ADDENDUM

NO. 1

PROJECT NAME: New Operations Building

PROJECT NUMBER: 1971-05-01

Job No. 1971-05-01	Sheet No. G2.01
Drawn By: JT	
Date: 09/18/2025

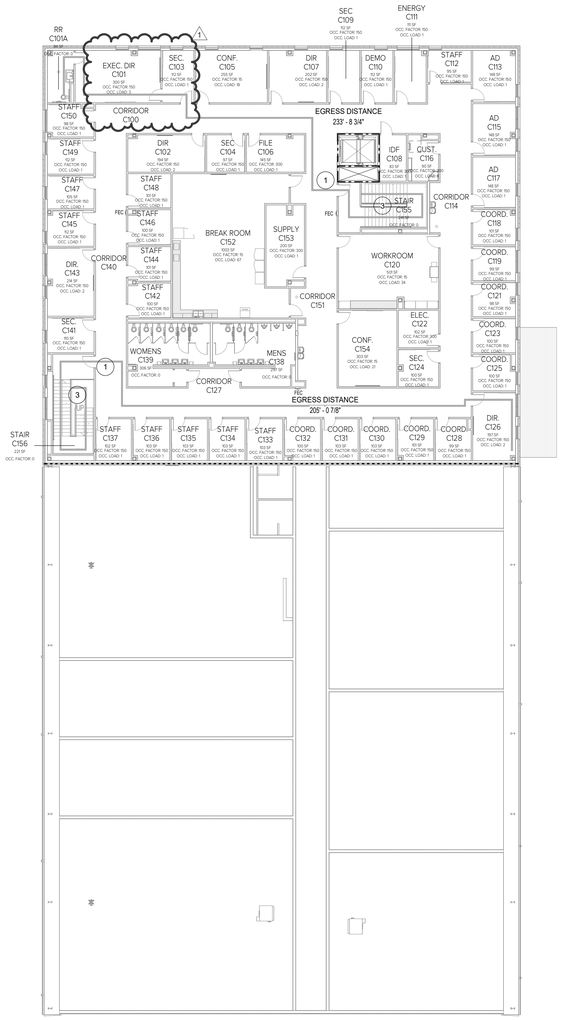
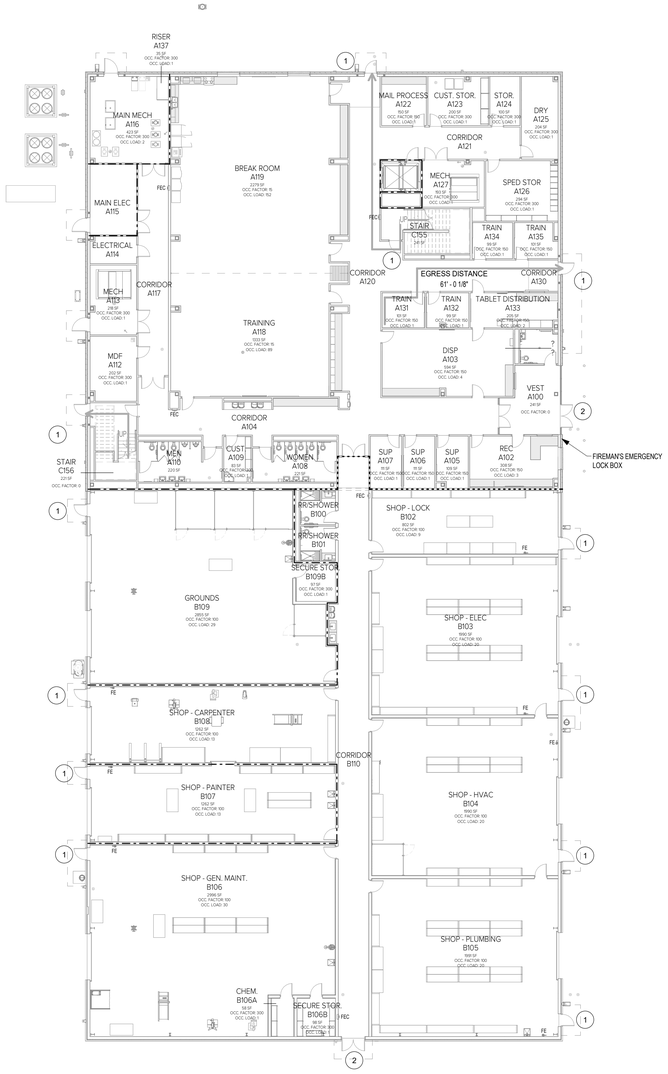
AD No 1, Arch. Item 32: To the Drawings, Sheet G2.01, "CODE ANALYSIS PLANS - OPERATIONS BUILDING,"
Refer to attached sheet for revised door arrangement at rooms C101 and C103.

3 SITE WAYFINDING SIGNAGE
1" = 1'-0"

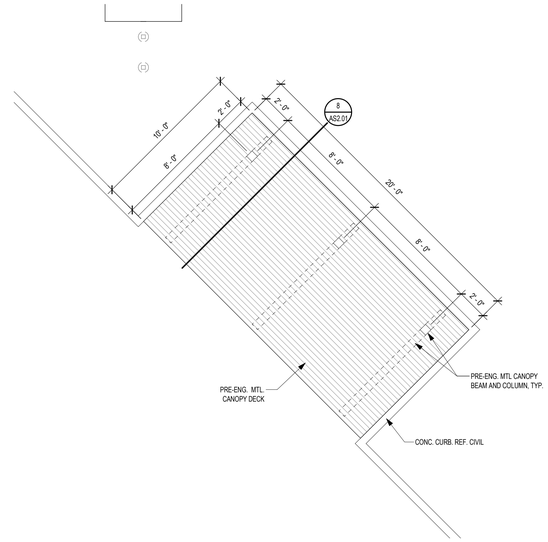
AD No 1, Arch. Item 33: To the Drawings, Sheet AS1.01, "ARCHITECTURAL SITE PLAN,"
Refer to attached sheet for the following revisions

1) Revised Comments column of the "SITE GATE SCHEDULE" to clarify access control at motorized gates.
2) Added detail callout for railing at the loading dock retaining wall
3) Added Detail 3 for site wayfinding signage and called out locations on the plan

14 DOUBLE CHAIN LINK GATE
1/2" = 1'-0"

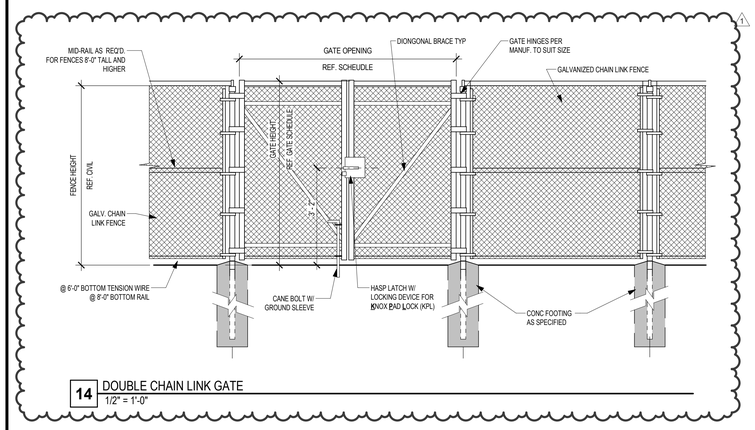
AD No 1, Arch. Item 34: To the Drawings, Sheet AS2.01, "ARCHITECTURAL SITE DETAILS,"
Refer to attached sheet for the following revisions:

1) Added Detail 14 for double chain-link gate.
2) Added Detail 15 for railing at the loading dock retaining wall.

Job No.	Sheet No.
1971-05-01	A1.01
Drawn By: JT	
Date: 09/18/2025

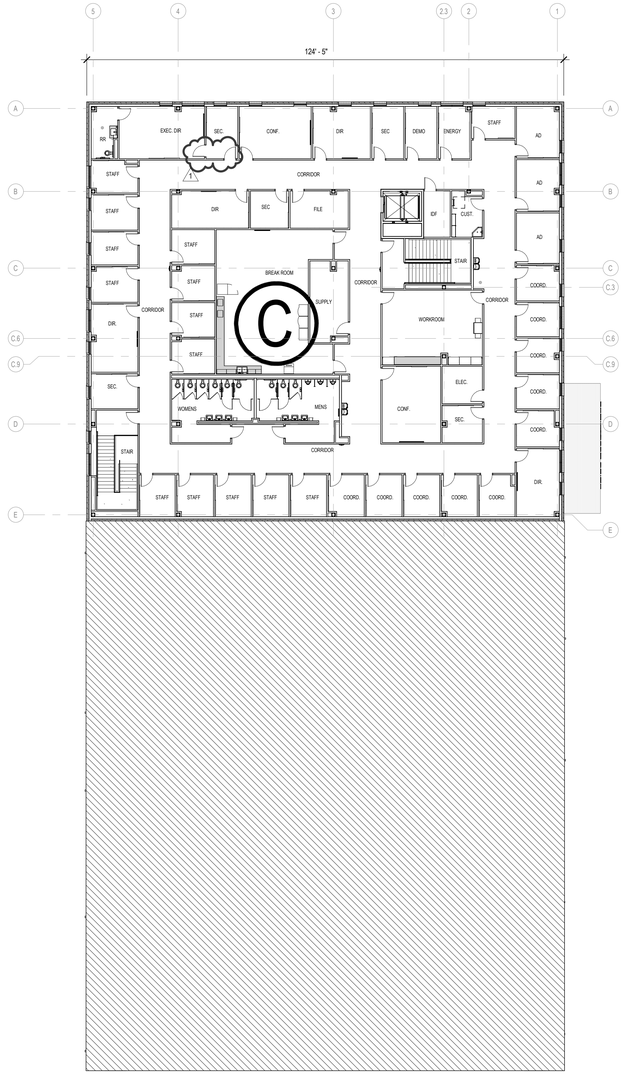
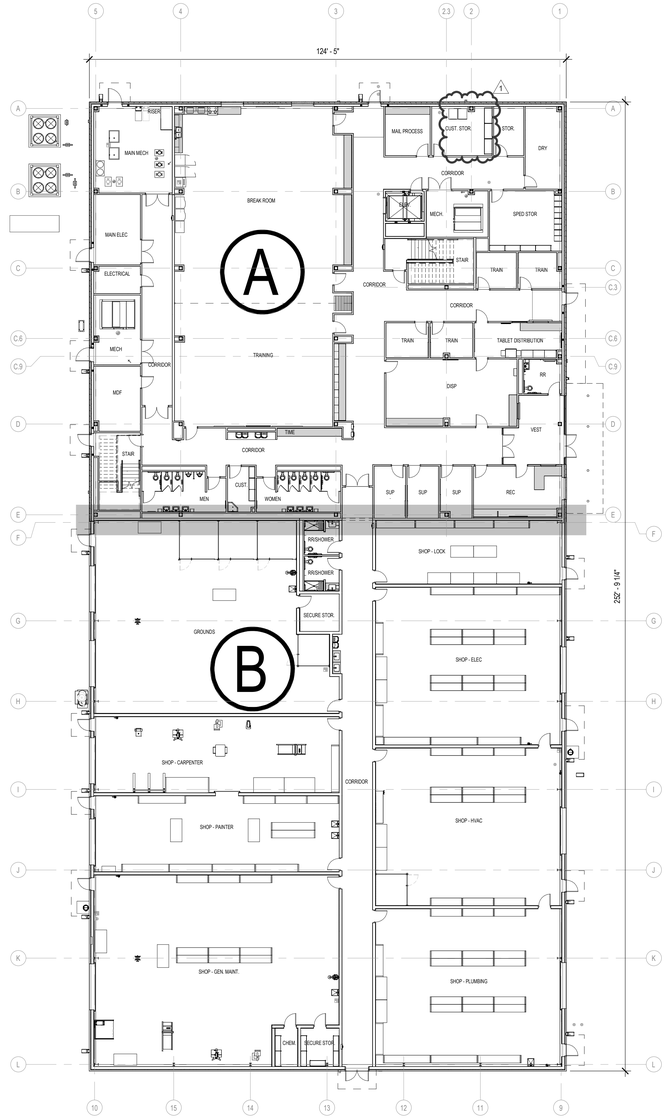
AD No 1, Arch. Item 35: To the Drawings, Sheet A1.01, "MASTER FLOOR PLANS - OPERATIONS BUILDING,"
Refer to attached sheet for the following revisions:

Job No.	Sheet No.
1971-05-01	A1.02
Drawn By: JT	
Date: 09/18/2025

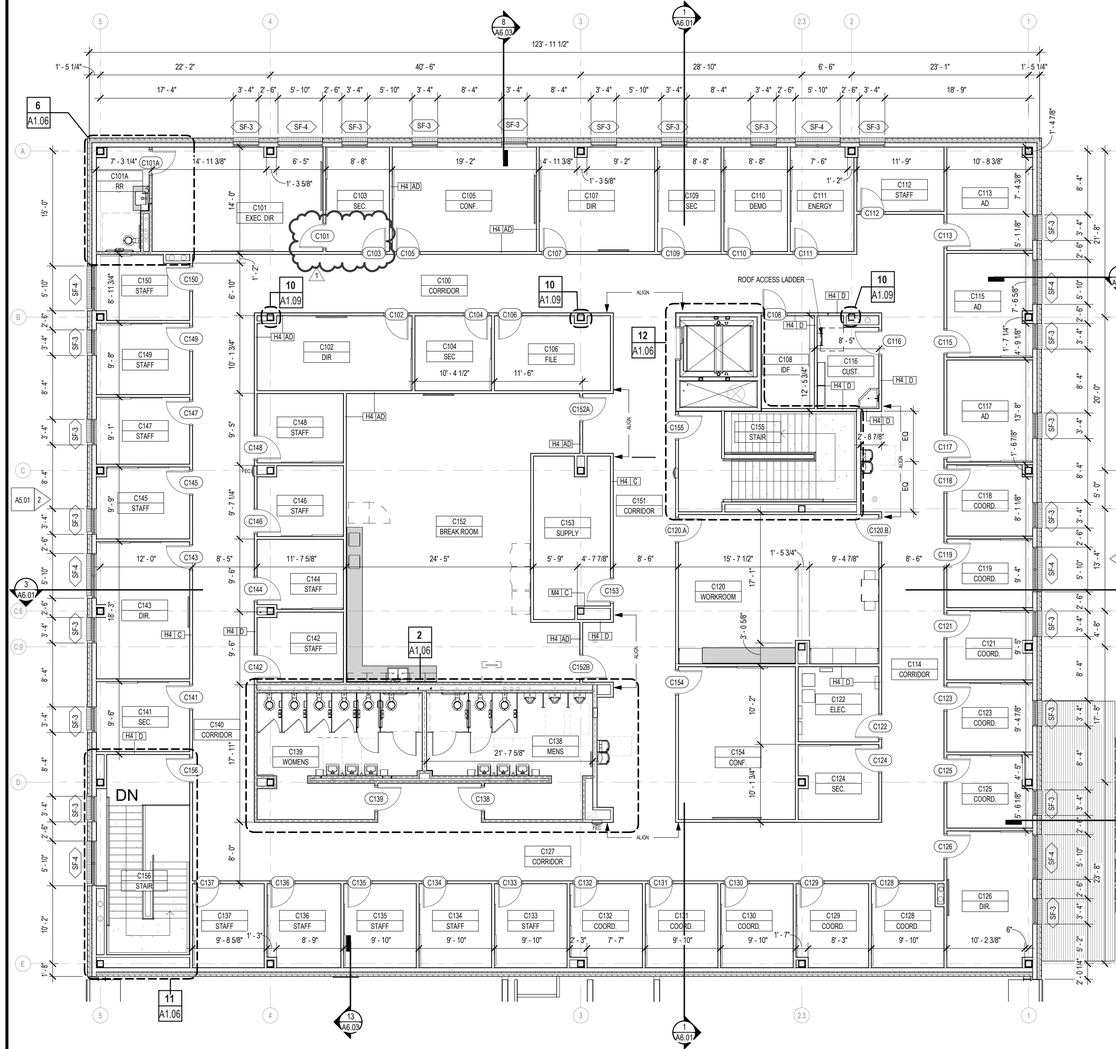
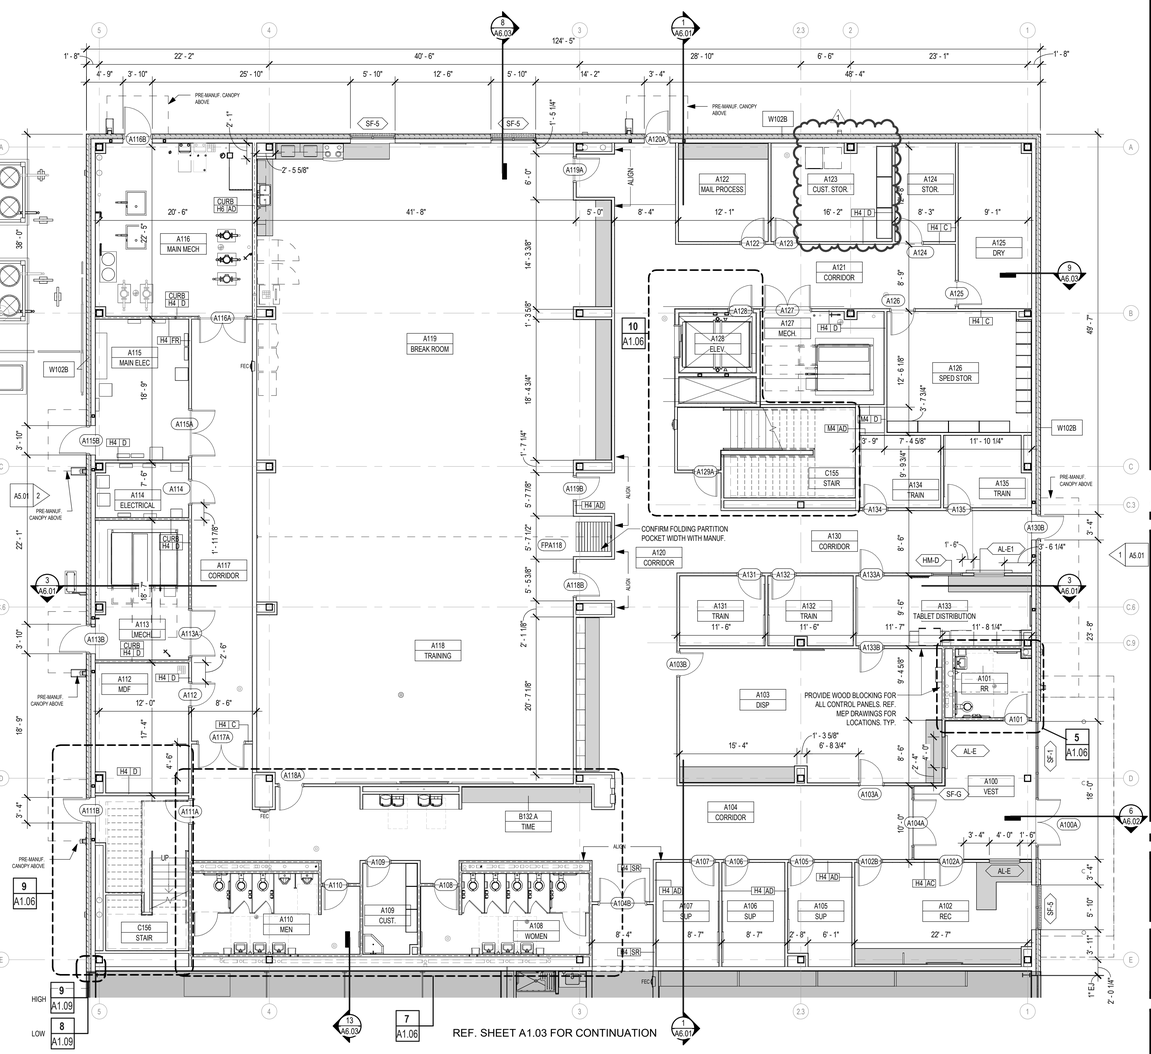
AD No 1, Arch. Item 36: To the Drawings, Sheet A1.02, "FLOOR PLAN - LEVEL 1 & 2 - AREA A & C - OPERATIONS BUILDING,"
Refer to attached sheet for the following revisions:

1 FLOOR PLAN - LEVEL 1 - AREA B - OPERATIONS BUILDING
1/8" = 1'-0"

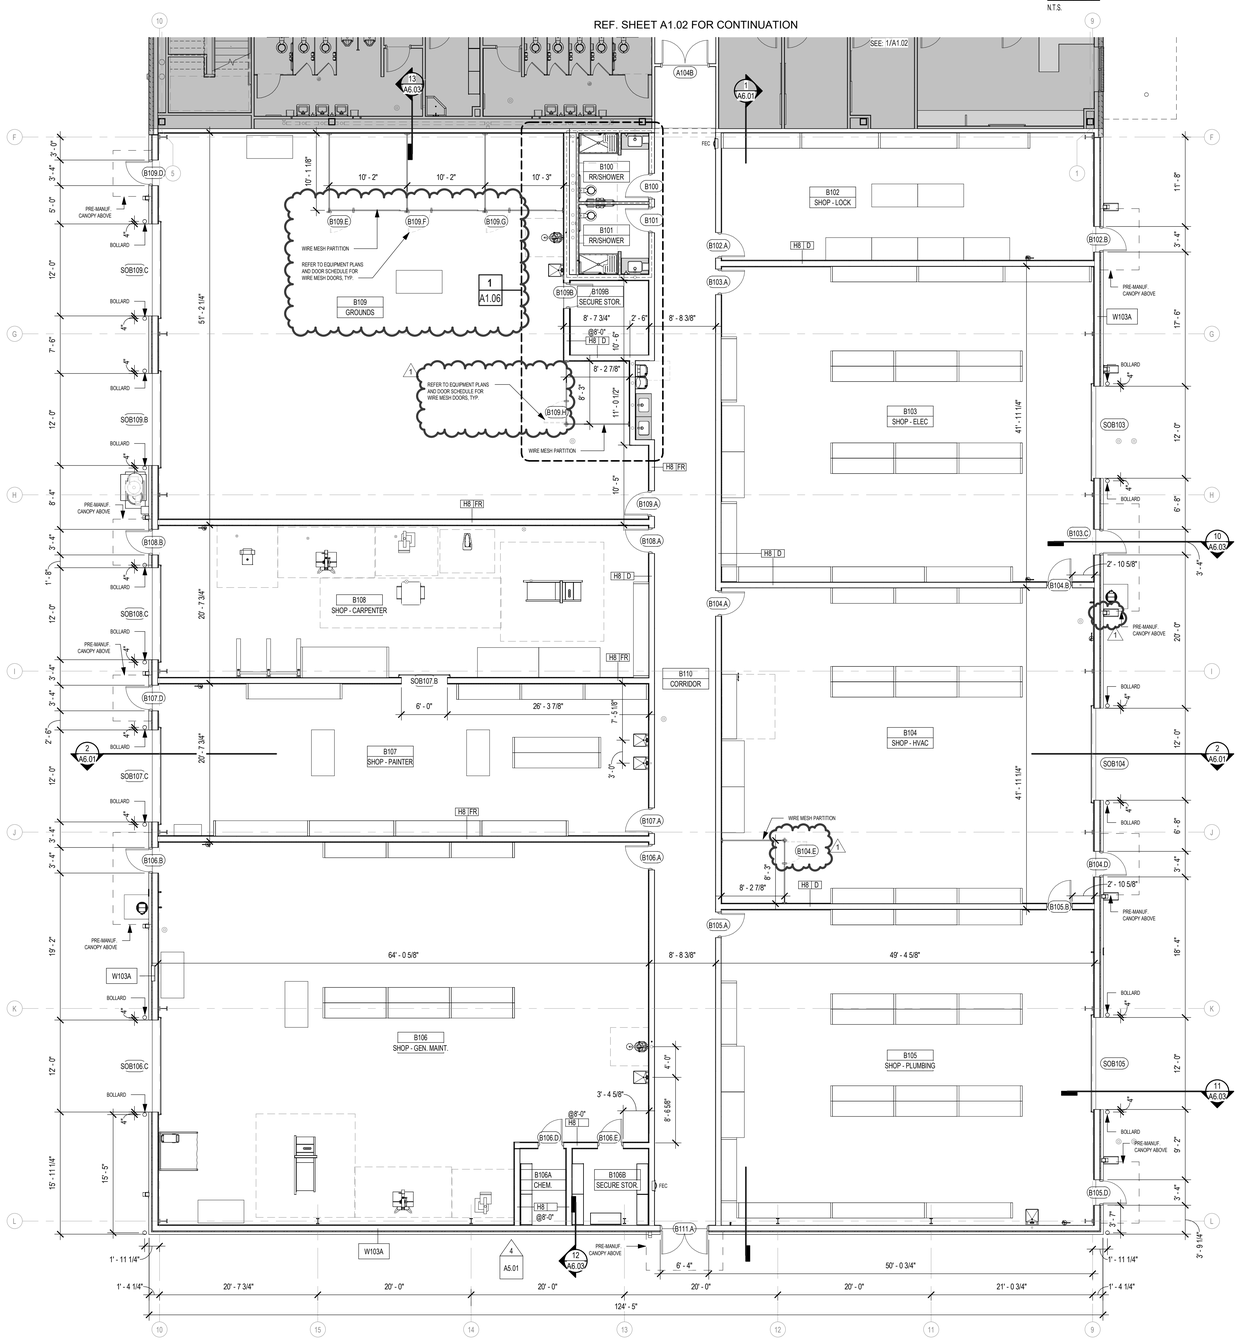
AD No 1, Arch. Item 37: To the Drawings, Sheet A1.03, "FLOOR PLAN - LEVEL 1 - AREA B - OPERATIONS BUILDING,"
Refer to attached sheet for the addition of door numbers at the wire mesh partition doors and revised note.

1 FLOOR PLAN - LEVEL 1 - AREA D - WAREHOUSE
1/8" = 1'-0"

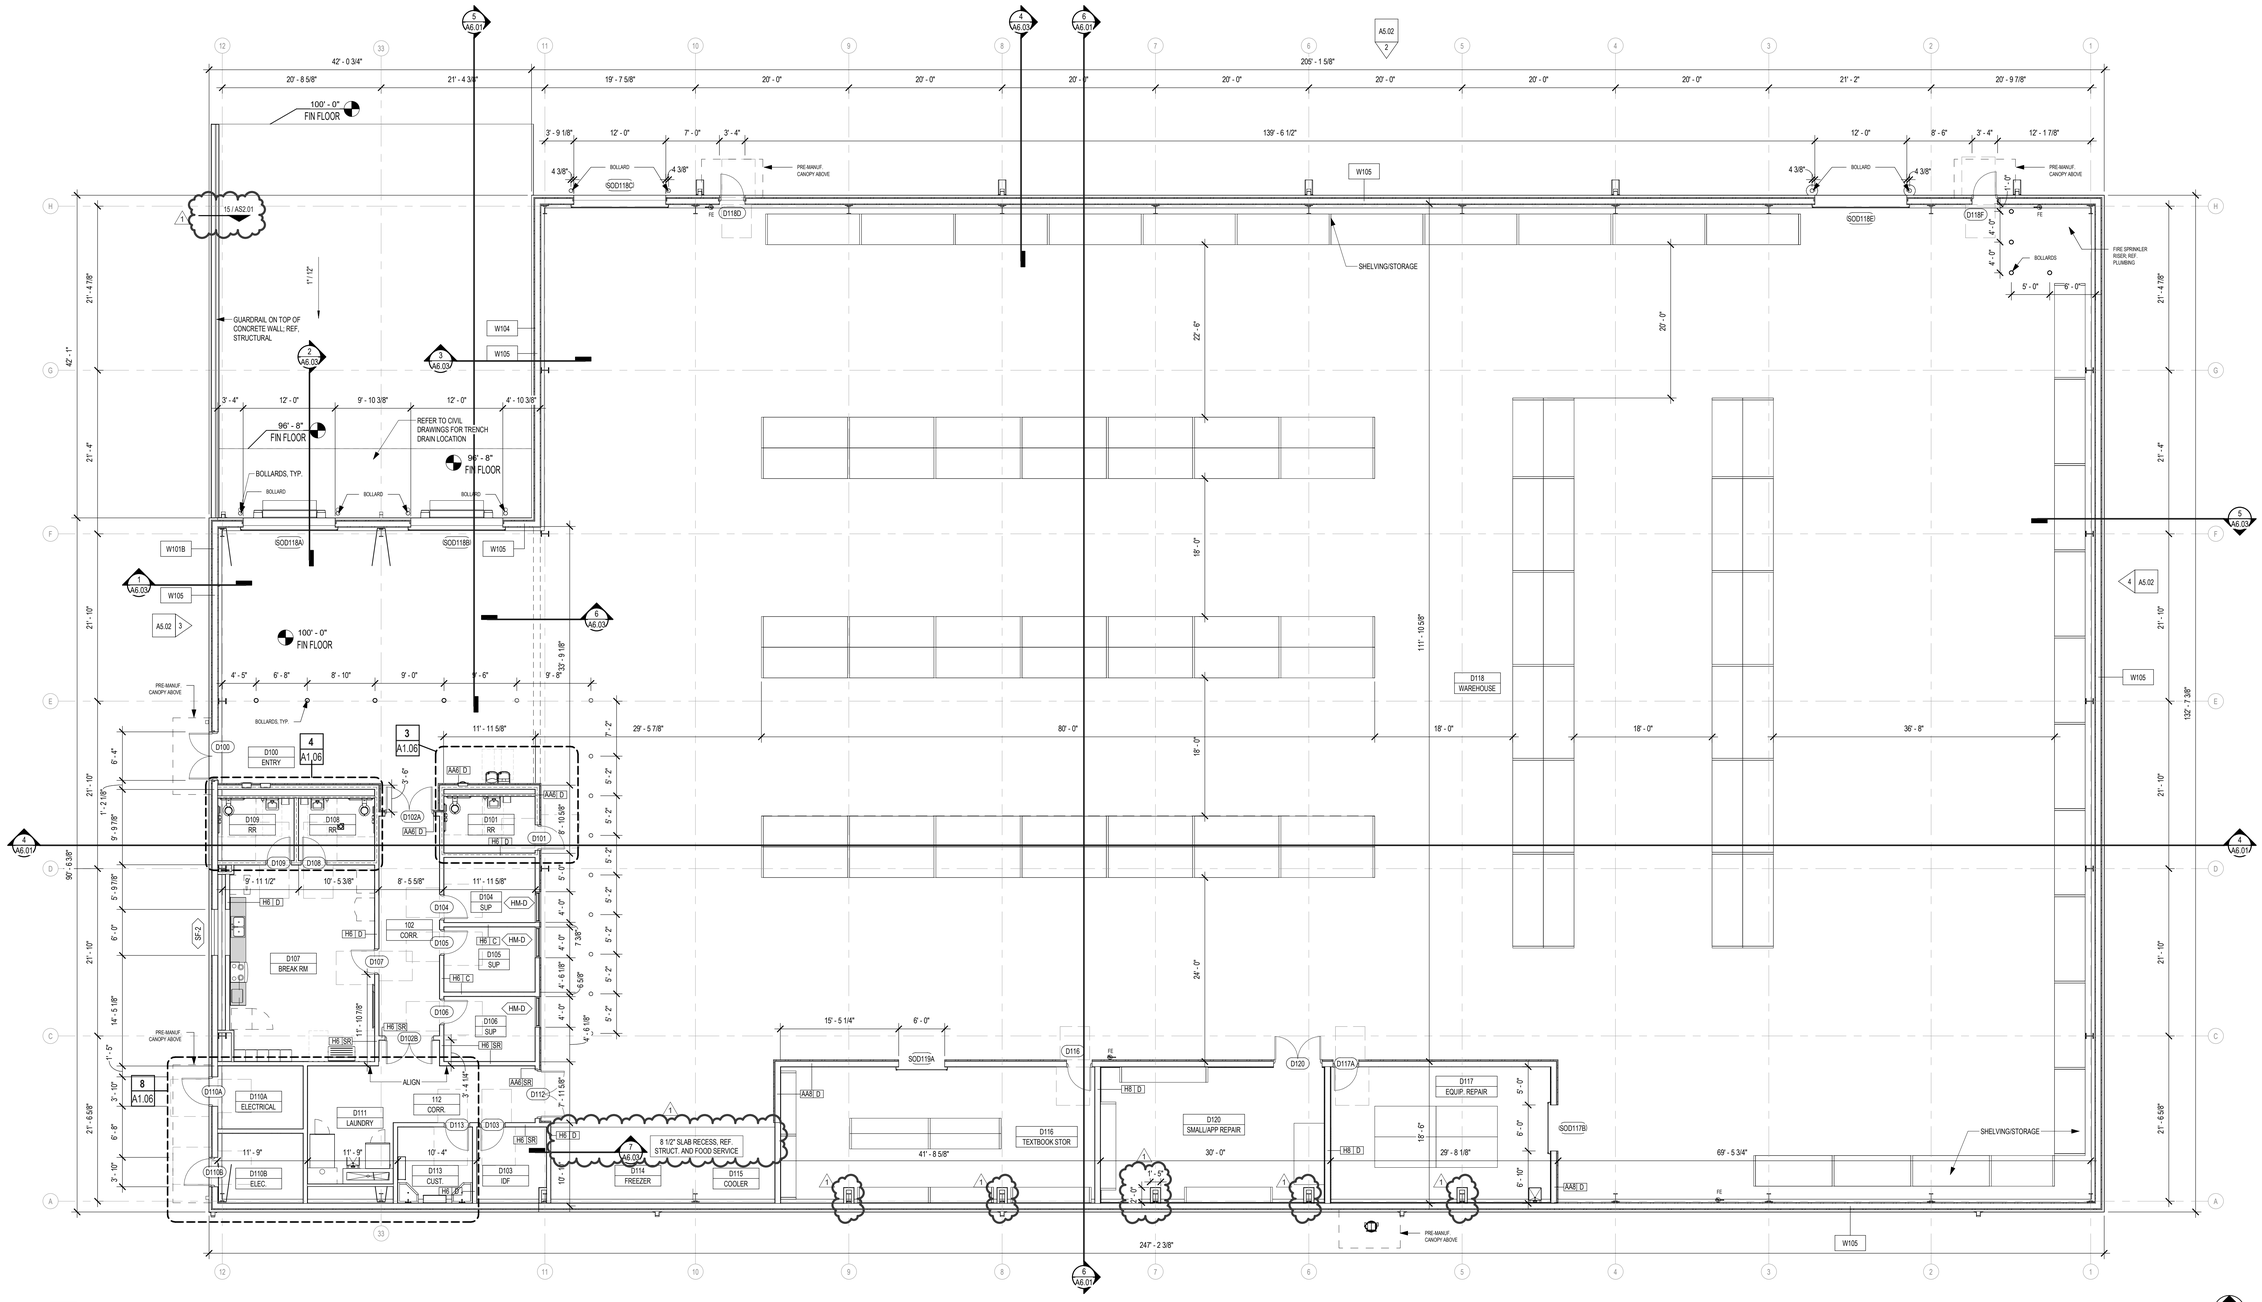
AD No 1, Arch. Item 38: To the Drawings, Sheet A1.04, "FLOOR PLAN - LEVEL 1 - AREA D - WAREHOUSE,"
Refer to attached sheet for the following revisions
